Access Compliance Report Public Rights-of-Way (Curb Ramps)

Intersection ID: 49933 Main Street: MARVIN_RD Cross Street: WOBURN_RD Location: NE **Overall Compliance: No Severity Score:** ADA ID: 074A7A8D0A70 Ramp Type: Perp Initial Pass/Fail: Fail 12.5

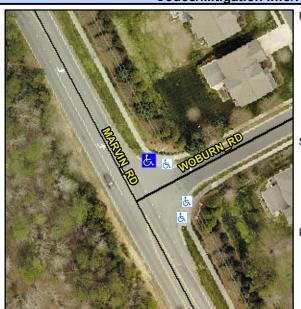
MARVIN RD Street 1 Name Stop Condition-Street 2 None Street 2 Name N/A Stop Condition-Street 1 N/A Possible Solutions: Remove & Replace Entire Ramp. Surveyor Notes: N/A PROW/ADA: Not Found, R304.5.3

Field Measurements/Component Compliance								
Compl	iance Description	Data	Compl	iance	Description	Data		
N/A	Ramp Length (in)	59.0	Yes	Ramp	Slope (%)	7.3		
Yes	Ramp Width (in)	48.0	No	Ramp	XSlope (%)	5.1		
N/A	Flare Type LT	N/A	N/A	Flare	Type RT	N/A		
N/A	Flare Slope LT (%)	N/A	N/A	Flare	Slope RT (%)	N/A		
N/A	Flare Traversable LT?	N/A	N/A	Flare	Traversable RT?	N/A		
N/A	Landing Length (in)	N/A	N/A	DWS	Provided?	N/A		
N/A	Landing Width (in)	N/A	N/A	DWS	Contrast?	N/A		
N/A	Landing Slope (%)	N/A	N/A	DWS	Length (in)	N/A		
N/A	Landing X Slope (%)	N/A	N/A	DWS	Full Width?	N/A		
N/A	Landing Curb? (Y/N)	N/A	N/A	DWS	Offset (in)	N/A		
N/A	Shared Landing?	N/A						
N/A	Gutter Ponding?	N/A	N/A	Gutte	r Slope (%)	N/A		
N/A	Gutter Lip Ht (in)	N/A	N/A	Gutte	r X Slope (%)	N/A		
N/A	Painted X Walk1?	No	N/A	Paint	ed X Walk2?	N/A		
	X Walk 1 Direction	To W		X Wa	lk 2 Direction	N/A		
N/A	X Walk 1 Width (in)	N/A	N/A	X Wa	lk 2 Width (in)	N/A
